Save Our Bays

Public Consultation Submission

“Response to MMO request for further information”

MLA/2023/00227

Figure 1: Pictures of North Sea Farmer’s anchoring system – AB have misunderstood ‘eco-anchors’ to be the same as their proposed ‘eco-blocks’.

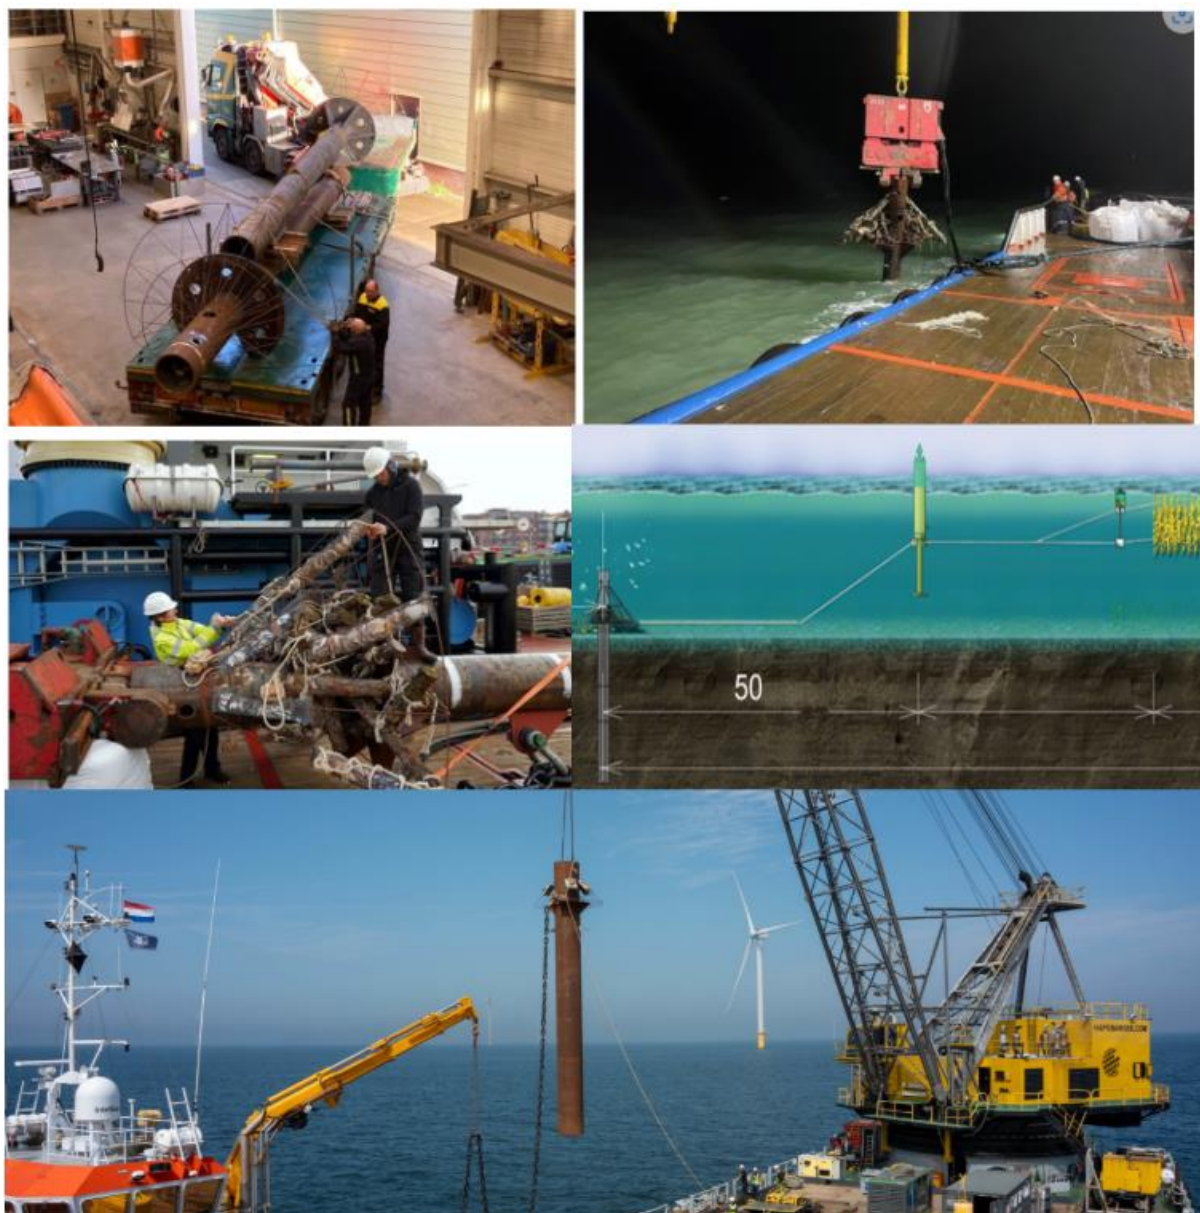
It is unclear why the North Sea Farmers pilot has been selected as evidence to support the use of gravity anchors in an exposed coastal location. While the anchors they use are called ‘Eco-anchors’ they are in no way comparable to gravity anchor blocks (so-called ‘eco-blocks’). The North Sea Farmers’ anchors are large metal piles that are driven into the seabed and then connected together with nets. No other North Sea Farmers projects appear to use gravity anchors.

The following pictures show the anchoring system in use by North Sea Farmers (see [link](#)). This is a completely different system to that proposed by Aqua Botanika.

Figure 2: Arc Marine schematic of the long line design proposed for use at Port Quin Bay.

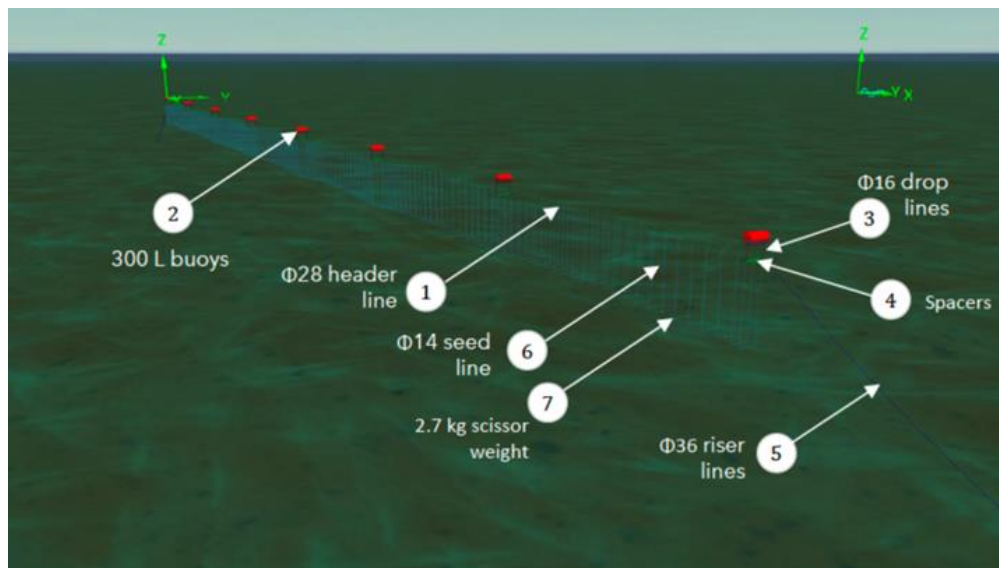
AB appears to be following the Port Quin Bay long line model for the farm layout, having changed this from a grid system. It is reasonable to assume, therefore, that a similar long line configuration will be used for each of the 250 long lines proposed. This is shown by AB and Biome Algae's design consultants as follows:

The one difference is that AB proposes using 'up to four lines' per 160m long line, which increases the number of seed lines required. This would result in a configuration consisting of:

- 8 navigational buoys (4 for the corners and 4 for the midpoints)
- 2,000 x 300l long line buoys (each long line has 8 of these)
- 1,000 x 160m header lines (each of the 250 long lines has 4x header lines)
- 4,000 drop lines (2 per 300l buoy)
- 508 riser lines (2 per long line, 8 independent navigational marker risers)
- 80,000 seed lines (320 per long line)

Calculating the length of the various different lines, this amounts to **c.900,000m of rope** to be deployed at full scale; and **2,008 buoys**. Given the dynamic sea conditions off Combe Martin the risk of lost gear and associated entanglement and marine pollution risk is significant.

Figure 4: Changes to the overall layout from a grid system in the original application to a long line system in the current document

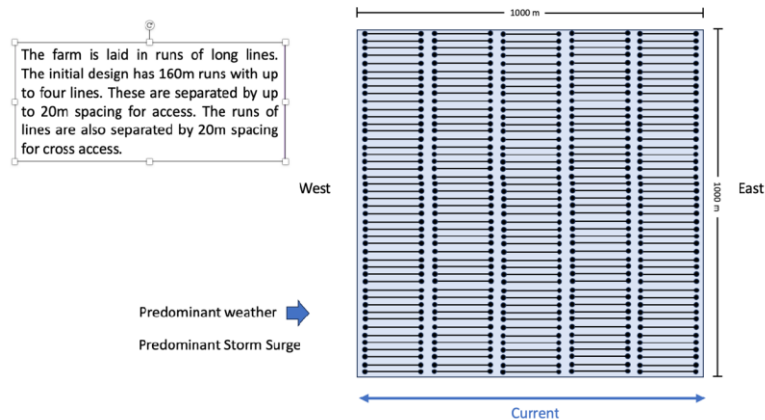
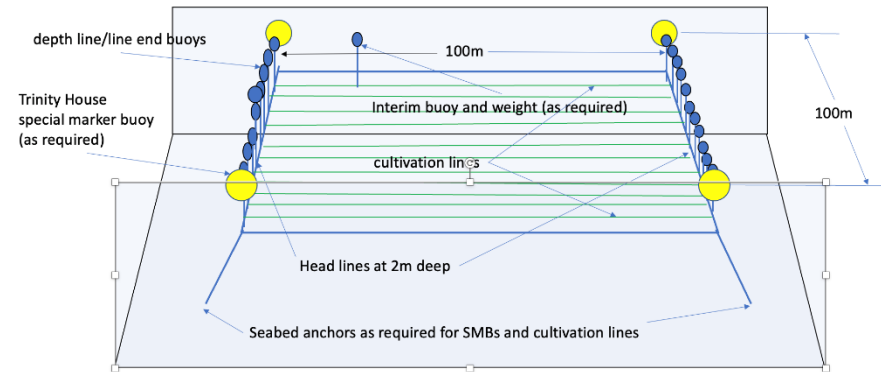
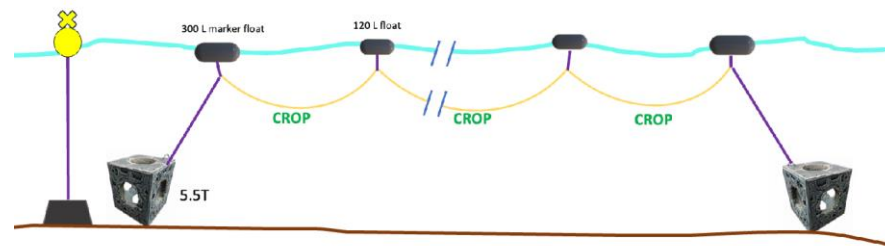
The applicants have significantly changed the proposed farm layout from their original feasibility study. This is the case for both the overall layout, and the individual long line / grid array. See *Figure 3* at the end of this sub-chapter. No rationale is provided for this change, however the applicants state that:

In other words, the application contains no usable information describing the system Aqua Botanika will eventually install on which to make an assessment of the risk associated with this proposed seaweed farm. This is unique in all Marine Licence Applications for seaweed farms that have been submitted to the MMO for consideration.

Figure 9: Comparison of recorded annual wave height data for Bideford and Torbay wave buoys (source: CEFAS WaveNet, [link](#))

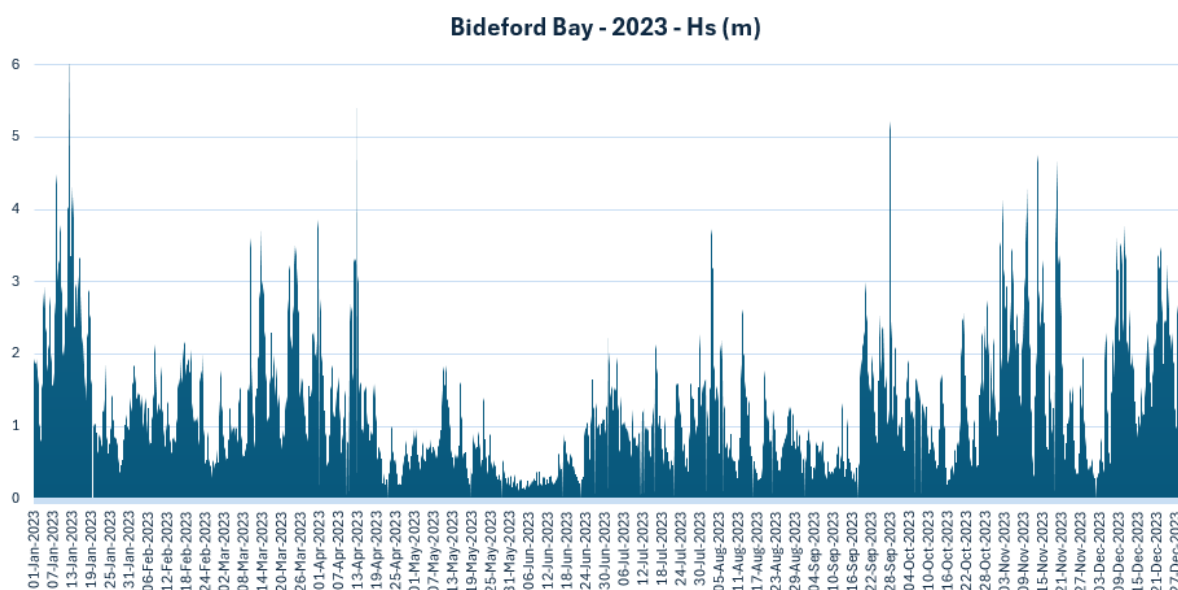
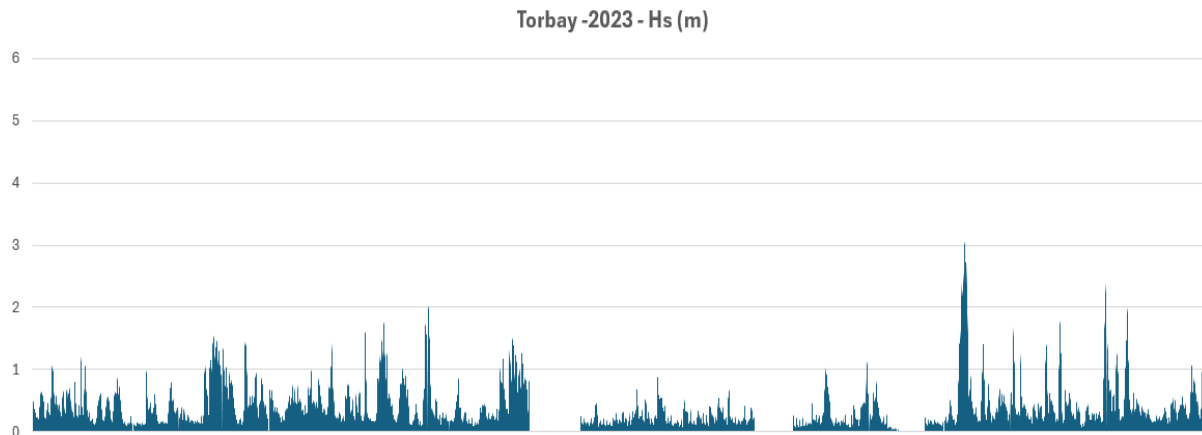
The applicant claims that data collected over 2023 has led to them changing their design approach for the mooring from screw anchors to concrete blocks. As such 2023 data will be used for comparison, although this follows the same trend across all years.

Data spikes have been removed from the Bideford dataset where sig wave heights were over 6m, to ensure a conservative approach was taken. Gaps in the Torbay dataset relate to missing data. In addition, the Scarweather wave buoy, located ~30km north of Combe Martin in the Bristol Channel, shows a similar profile to the Bideford Bay wave buoy.

Figure 10: Tor Bay (left) and Scarweather (right) wave buoy observed and forecast significant wave height data during Storm Darragh, showing less than 1m for Torbay and 5.9m for Scarweather ([link](#)).

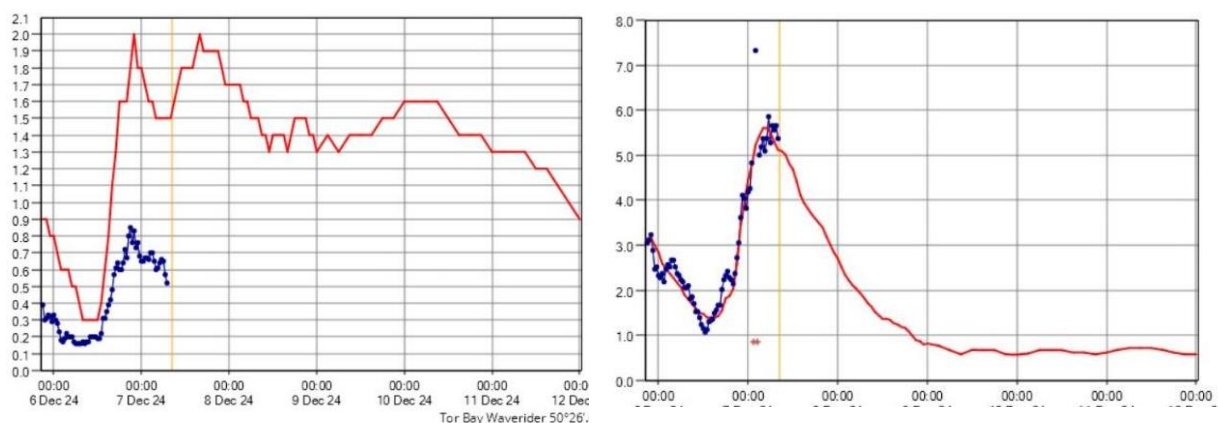
To further emphasise the point, see below comparison of significant wave height observed and forecast data between Scarweather and Tor Bay wave buoys, accessed on Dec 6th prior to Storm Darragh:

It is clearly apparent that the Torbay wave buoy observed far smaller wave heights compared to Bideford, both as an average and maximum. This trend is also true for wave period. For example, the average wave period in 2023 was 10.25 seconds at Bideford and only 6.25 seconds at Torbay. When comparing the % of the dataset falling in certain categories of wave heights, this again reinforces the point that Torbay is not of comparable exposure to Combe Martin.

Figure 11: Example of the peak flow for a mean spring tide around the UK ([link](#))

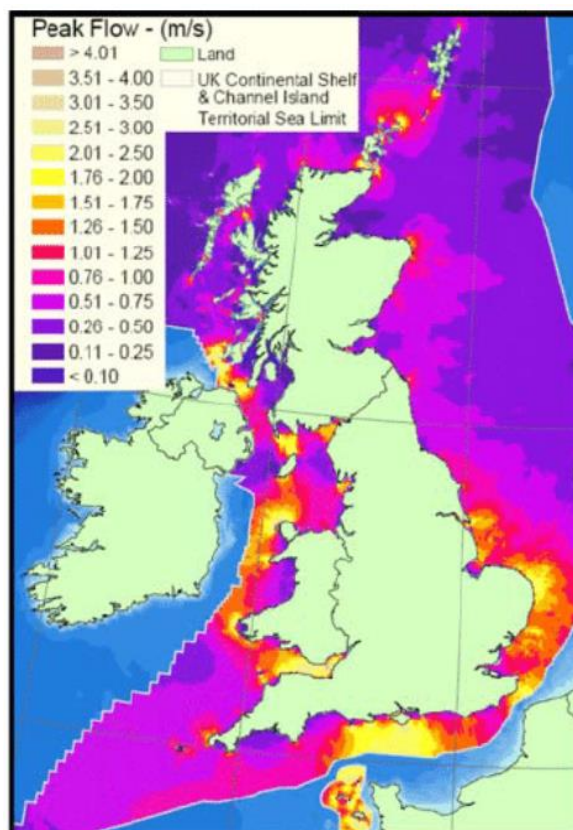
Currents play a critical role when determining the necessary anchor weight. The applicants routinely reference that there are strong currents in the area, and rightly so. As Figure 11 demonstrates, the currents off North Devon are amongst the strongest in the country, far stronger than both Port Quin and Torbay, due to the funnelling and tidal range within the Bristol Channel. The ABPmer dataset of metocean conditions, used by the applicants, gives a 'Mean Peak Spring Flow' of 0.13m/s in Torbay, compared to 1.50m/s at the proposed Combe Martin site.

Figure 17: EMODnet dataset included the X to mark the location assessed by the applicants. The red box demonstrates the actual location of the proposals, based of MMOs portal.

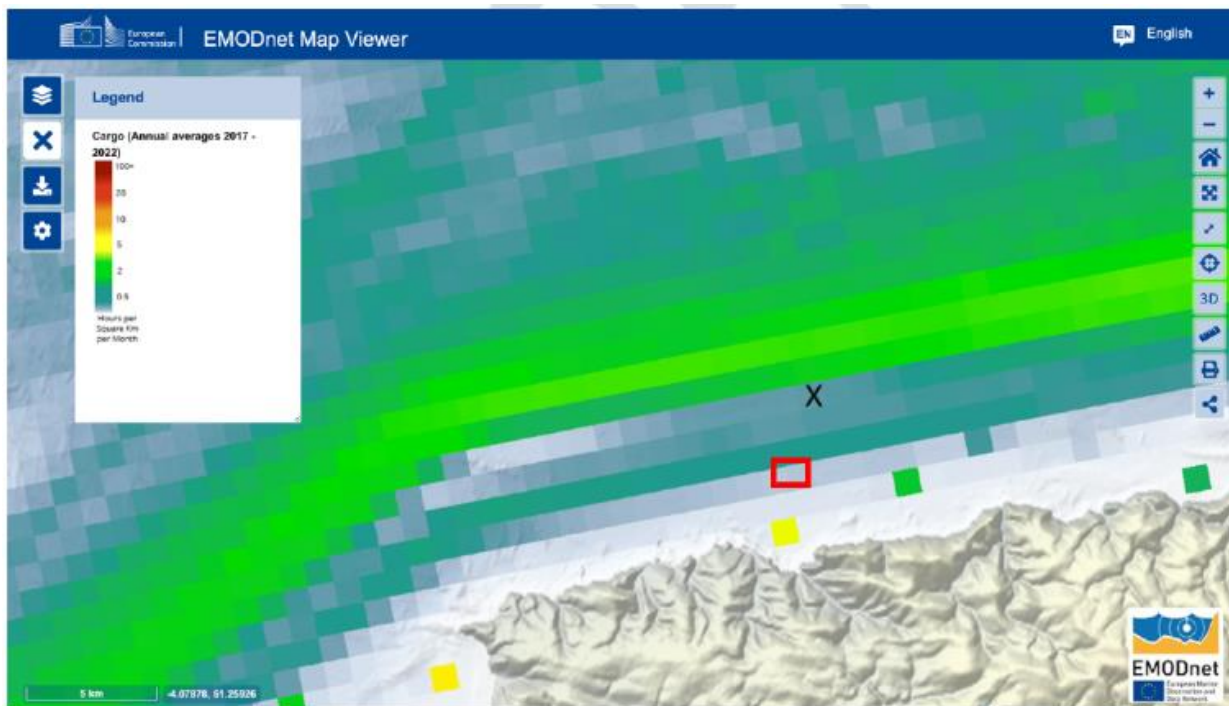
EMODnet data is used to inform the Navigational Risk Assessment. The applicants have indicated they have used data from a cell almost 2km away from the proposed site in error. As such, it is not possible to assess the conclusions drawn from this dataset. This is a significant oversight.

Vessels without AIS data focuses on potting activity. No reference has been made to the MMOs own dataset showing the sailing and recreational use potential for this location. The MMOs own mapping shows this site interacts with areas of Medium/ High potential.
